REPORT REF: 21105R03OPpak

CONSTRUCTION REVIEW - ACOUSTICS

PROPOSED 157 BEDROOM HAMPTON BY HILTON – BATH ROAD, HEATHROW

Figure 3.2: Recommended detail.

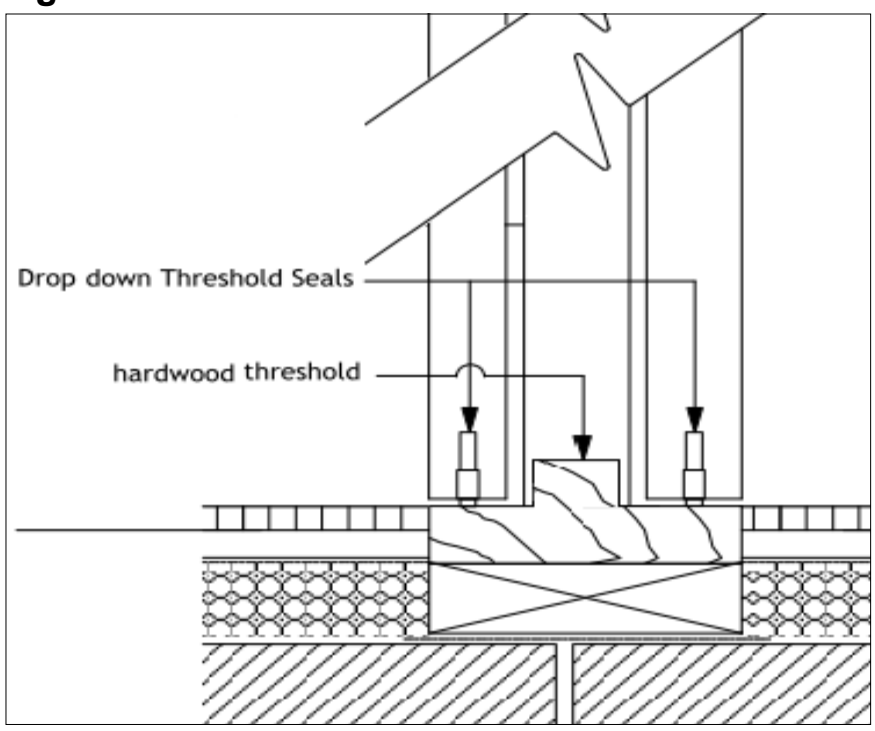
3.11.1 Interconnecting door sets are proposed between a number of guestrooms. The door sets between guestrooms must provide an airborne sound insulation performance of 55dB $D_{n,T,w}$ (43dB $D_{nT,w}$ + C_{tr}) or greater, equivalent to that of the separating wall in which it is installed.

- Doors should be ≥54mm thick solid core doors with neoprene 'batwing' or 'bulb/ compression' seals around the head and perimeter with drop down threshold seals which should sit on a hardwood threshold plate.
- The door frame should be 'split' to offer greater isolation to each door leaf.
- There should be no gaps around the doors and reveals should be lined with absorbent material so that there is no build of sound within the cavity. The lining can be bonded carpet if desired.
- A 15mm high timber threshold strip should be installed between back to back doors to reduce flanking noise transmission at the threshold (i.e. an inverse 'T' threshold section). Our recommended threshold details are shown in Figures 3.2 and 3.3. The details should be signed off by Whitbread before being built.

Figure 6.1 Typical junction details

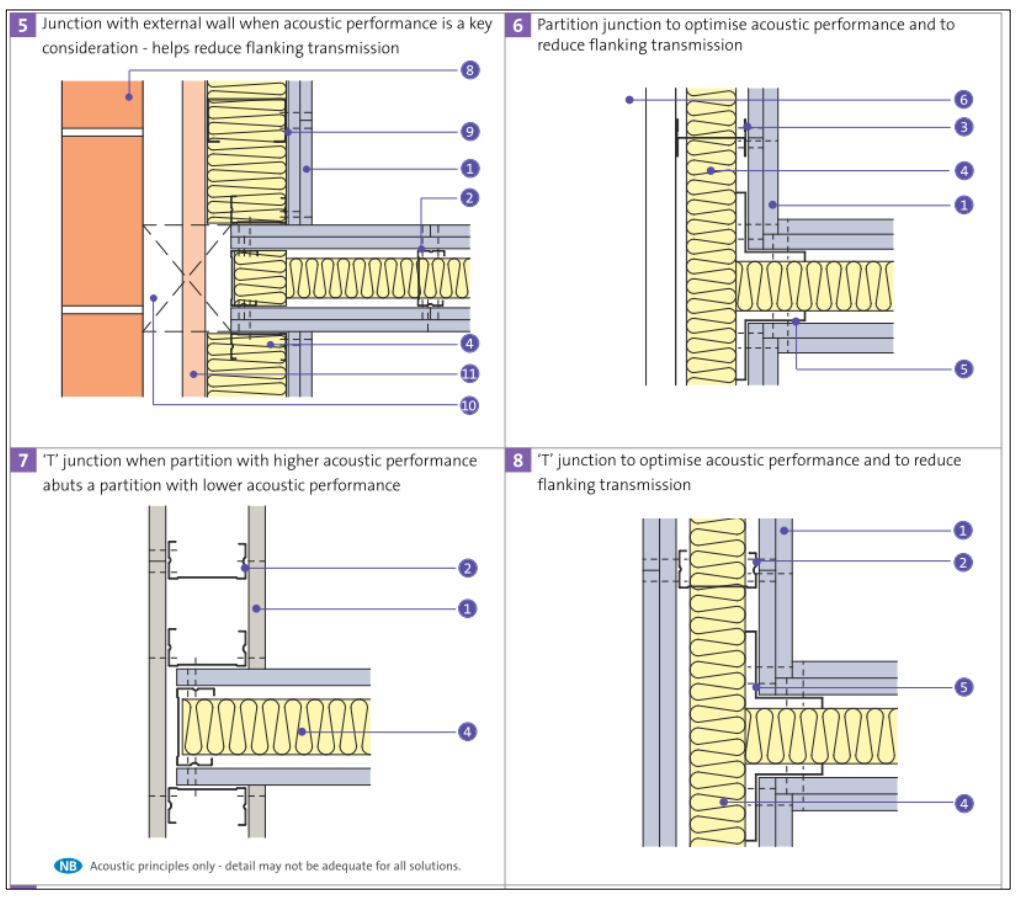
6.1.5 Plasterboard layers at junctions with separating walls and floors should not be continuous across the separating partition. This applies to internal linings of external walls and corridor walls, see Figure 6.1 for typical junction details.

Figure 6.2: Good/ bad practice for fitting sockets.

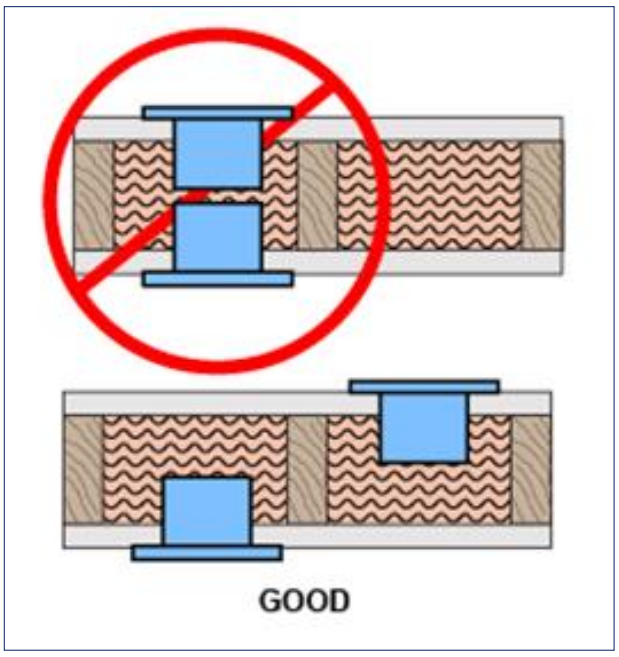
6.2.2 Back to back sockets in stud walls should be avoided where possible, see Figure 6.2 for good and bad practice.

6.2.3 The sockets should be staggered and treated with a suitable mouldable fire-rated putty pad (see suitable application in Figure 6.3) e.g. ‘Hilti’ or ‘Rockwool’ putty pads, see:

Figure 6.4: External wall and floor example detail.

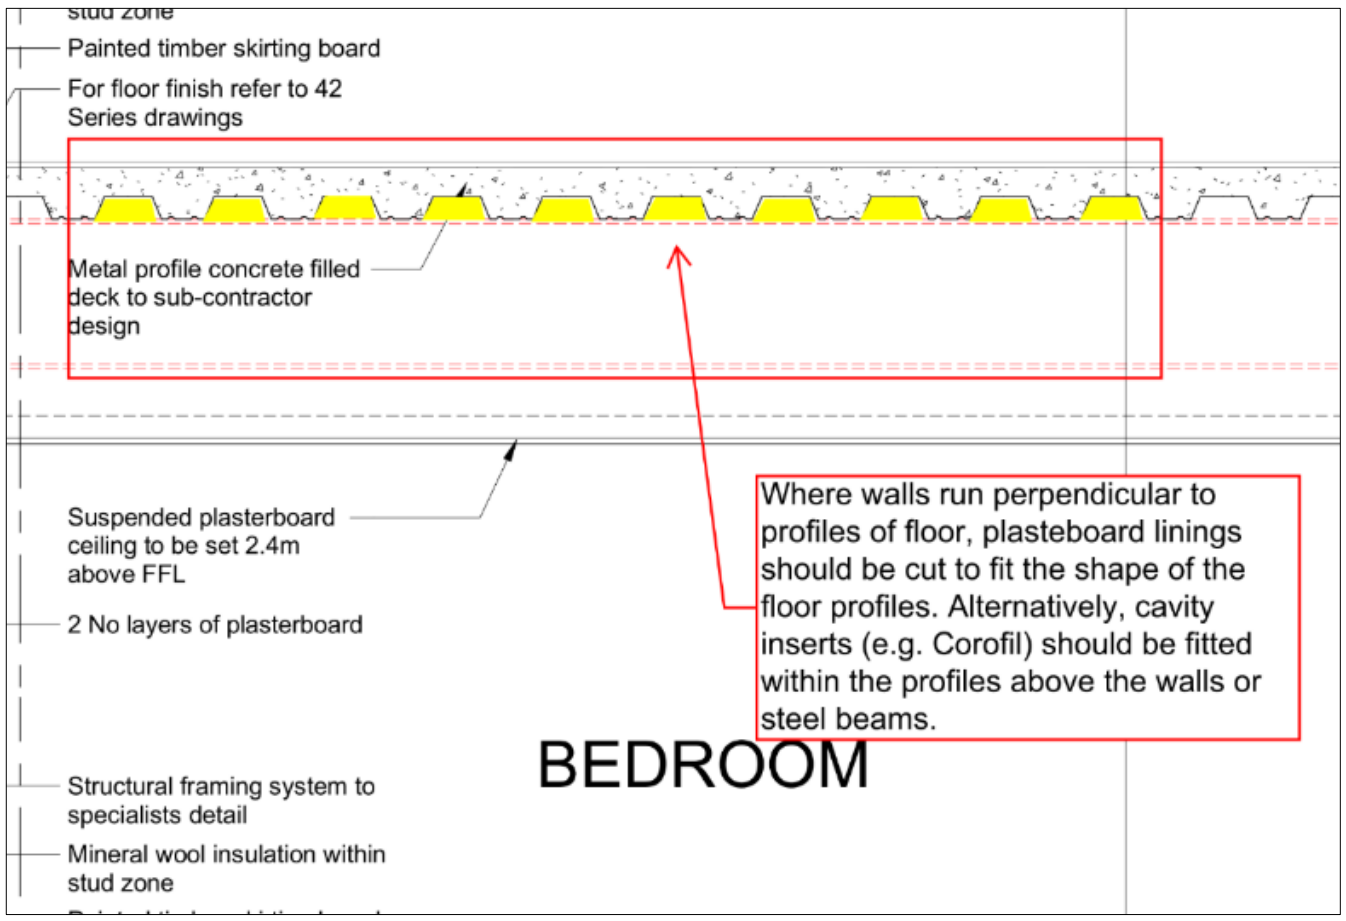
6.4.3 Rockwool type cavity inserts (e.g. Corofil C144) should be installed across the partition within the formed cavities (see Figure 6.4). This is also applicable above any steel beams at separating wall lines.

Figure 8.1: Lift Location.

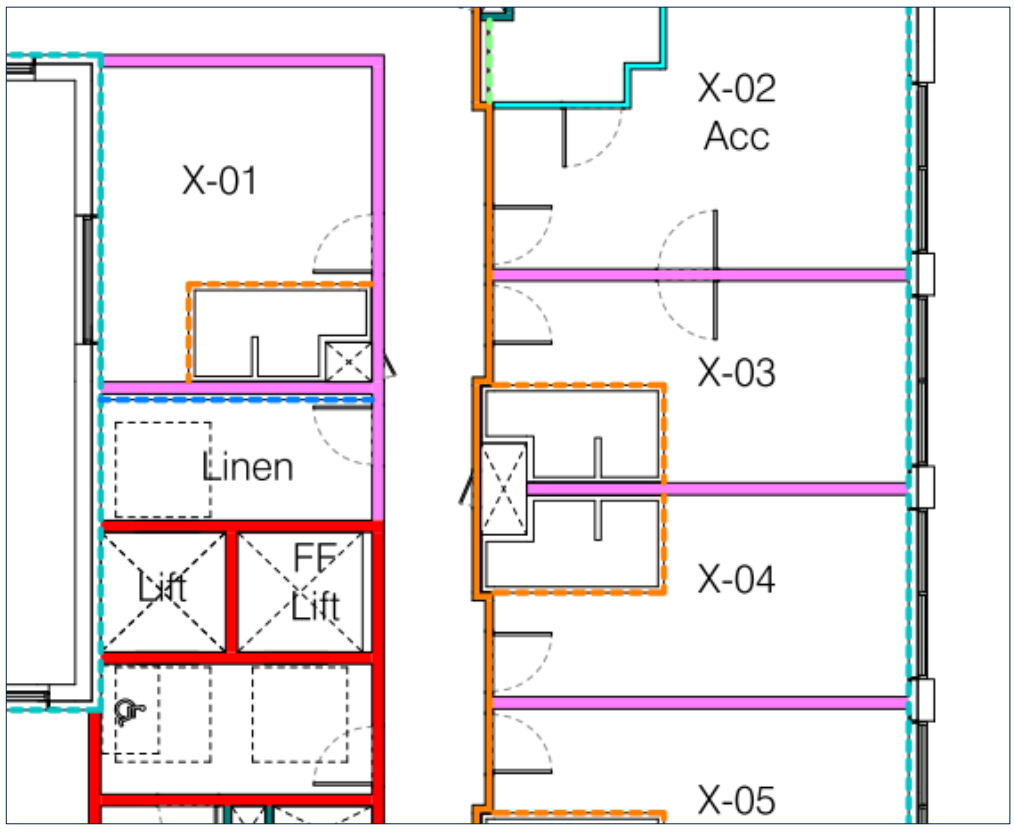
8.2.1 No lift shafts are proposed adjacent to guestrooms. The closest lift shafts are separated from guestrooms by either corridors or linen rooms, See Figure 8.1.

8.2.2 The lift shaft shall be detached from the rest of the surrounding structure. Recommendations given in the following sections are applicable to the entire lift shaft ‘run’.
